**APPLICATION FOR PERMISSION
UNDER SECTION 16 OF
THE TOWN PLANNING ORDINANCE
(CAP.131)**

(b) Intended use/development 有意進行的用途/發展	擬議填土(約 0.6 米), 以作准許的農業用途 Proposed Filling of Land (by about 0.6m) for Permitted Agricultural Use

Application No. 申請編號	(For Official Use Only) (請勿填寫此欄)		
Location/address 位置/地址	新界元朗輞井圍 DD129 LOT 1396RP		
Site area 地盤面積	225.09	sq. m 平方米	<input checked="" type="checkbox"/> About 約 <input type="checkbox"/> Not more than 不多於
	(includes Government land of 包括政府土地	sq. m 平方米	<input type="checkbox"/> About 約
Plan 圖則	S/YL-LFS/11		
Zoning 地帶	V		
Applied use/ development 申請用途/發展	擬議填土(約 0.6 米), 以作准許的農業用途 Proposed Filling of Land (by about 0.6m) for Permitted Agricultural Use

Application No. 申請編號	(For Official Use Only) (請勿填寫此欄)		
Location/address 位置/地址	新界元朗輞井圍 DD129 LOT 1396SA		
Site area 地盤面積	218.25	sq. m 平方米	<input checked="" type="checkbox"/> About 約 <input type="checkbox"/> Not more than 不多於
	(includes Government land of 包括政府土地	sq. m 平方米	<input type="checkbox"/> About 約
Plan 圖則	S/YL-LFS/11		
Zoning 地帶	V		
Applied use/ development 申請用途/發展	擬議填土(約 0.6 米), 以作准許的農業用途 Proposed Filling of Land (by about 0.6m) for Permitted Agricultural Use

Figure 1 The application site (marked in red) is within WBA (marked in dark blue)

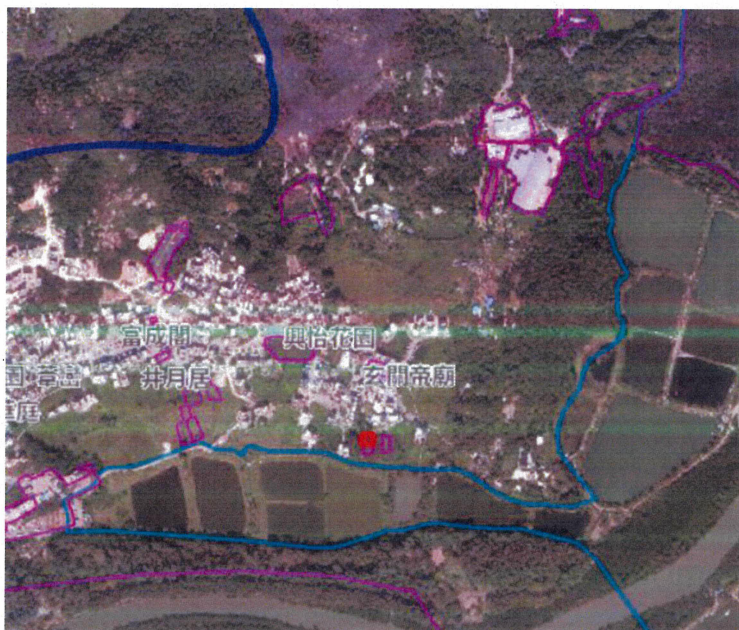
It is found that the application site falls into WBA (Figure 1) and very close to the Conservation Area which is within Wetland Conservation Area (WCA). According to application for Developments within Deep Bay Area under Section 16 of the Town Planning Ordinance (TPB PG-No. 12C), the intention of WBA is *“to protect the ecological integrity of the fish ponds and wetland within the WCA and prevent development that would have a negative off-site disturbance impact on the ecological value of fish ponds”*. However, the applicant fails to demonstrate that the proposed filling of land for 0.6m depth for cultivation of strawberry, broadleaf carpetgrass and grasses for sport field would not have negative off-site disturbance impact on the ecological value of the fish ponds and wetland.

Figure 1 The application site (marked in red) is within WBA (marked in dark blue)

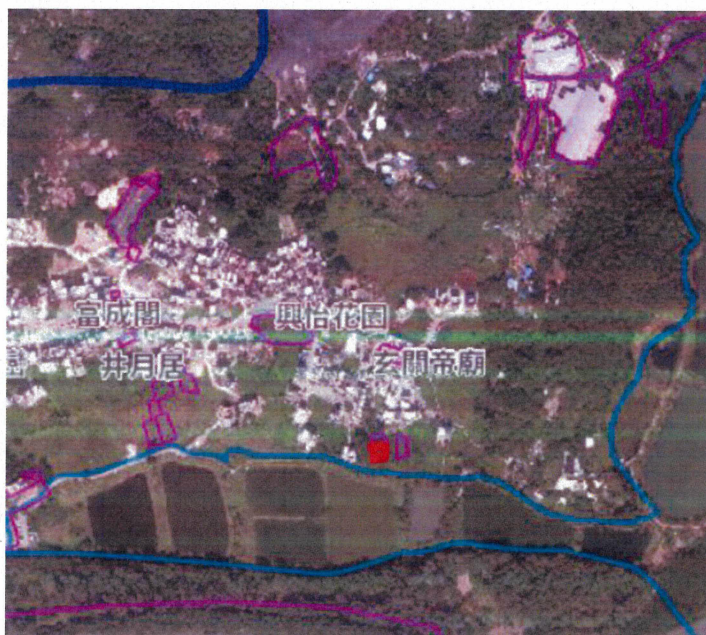
It is found that the application site falls into WBA (Figure 1) and very close to the Conservation Area which is within Wetland Conservation Area (WCA). According to application for Developments within Deep Bay Area under Section 16 of the Town Planning Ordinance (TPB PG-No. 12C), the intention of WBA is *“to protect the ecological integrity of the fish ponds and wetland within the WCA and prevent development that would have a negative off-site disturbance impact on the ecological value of fish ponds”*. However, the applicant fails to demonstrate that the proposed filling of land for 0.6m depth for cultivation of strawberry, broadleaf carpetgrass and grasses for sport field would not have negative off-site disturbance impact on the ecological value of the fish ponds and wetland.
